SUBJECT: NEW VEHICLE DEMONSTRATION / DELIVERY HOLD

Safety Recall 21S38 – Supplement #1

Certain 2021-2022 Model Year Bronco Sport, Corsair and Escape Vehicles
 Fuel Delivery Module (FDM) Line Leak Internal to Fuel Tank

New! REASON FOR THIS SUPPLEMENT

FIGURE 1

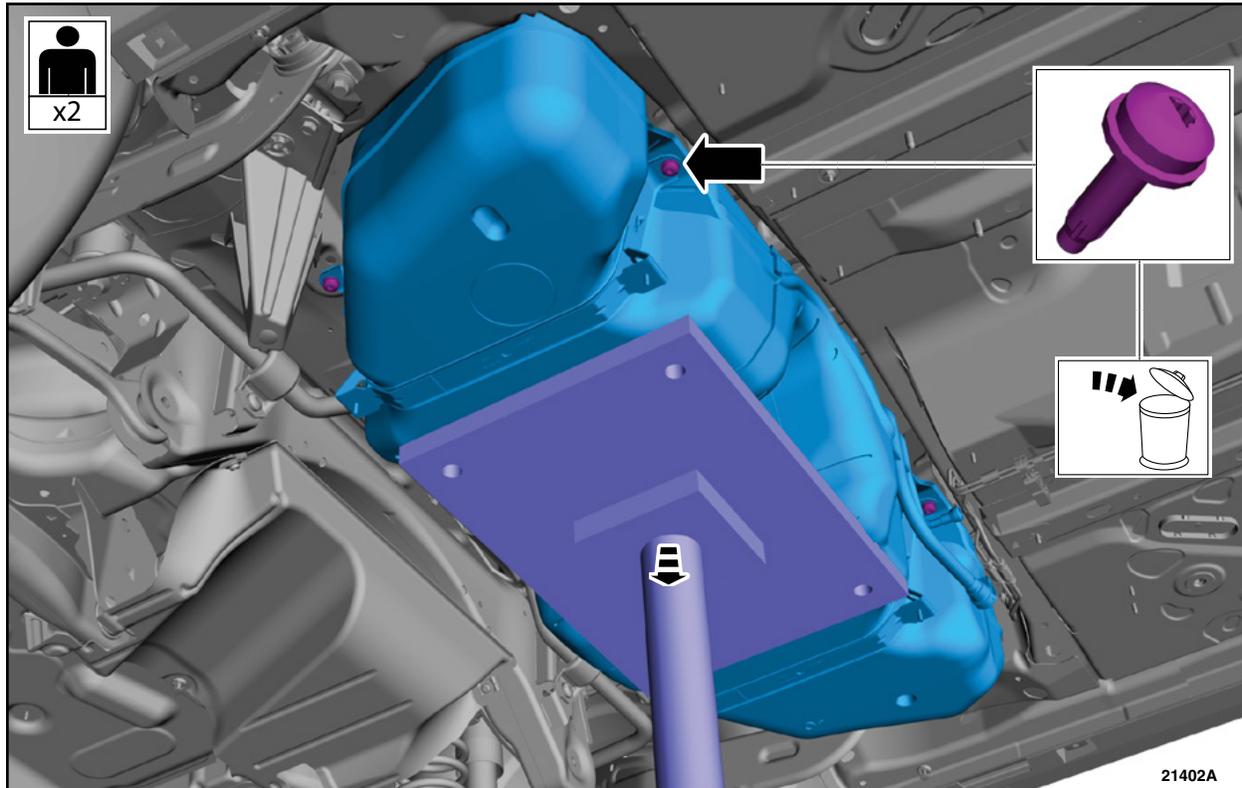
NOTE: The Fuel Tank Bolts (Figure 1) W711806-S4-50B are currently on backorder. Per the WSM this is a one-time use bolt due to the adhesive patch applied to the bolt. Due to this backorder, Dealers may re-use this bolt only ONCE by cleaning the threads using a wire brush and removing all residual adhesive. Apply 2-3 drops of Thread Locker Loctite 2422, or equivalent, to the original bolt in the original location of residual adhesive. Please see Figures 2 and 3 for the front and rear bolts and adhesive location.

- When W711806-S4-50B becomes available Dealers must install a new bolt per WSM.
